# PRODUCT CHANGE NOTIFICATION

### Bourns® Model SRN8040HA-1R0M Semi-shielded Power Inductor

#### *Change to Inductor Core Design*

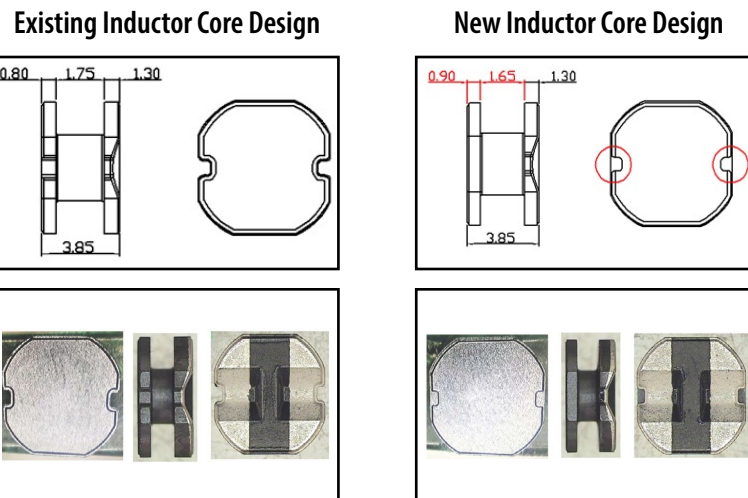
Riverside, California – January 24, 2022 – Effective March 19, 2022, Bourns will change the inductor core design for the Model SRN8040HA-1R0M Semi-shielded Power Inductor. The modified inductor core will have a thicker top flange, no wire channels on the top flange and a reduced winding area. These modifications will strengthen the core structure and help reduce the risk of a core crack.

The form and fit of the power inductor will change as a result of the described changes. The function of the power inductor will remain the same. The quality and reliability of the component should be improved.
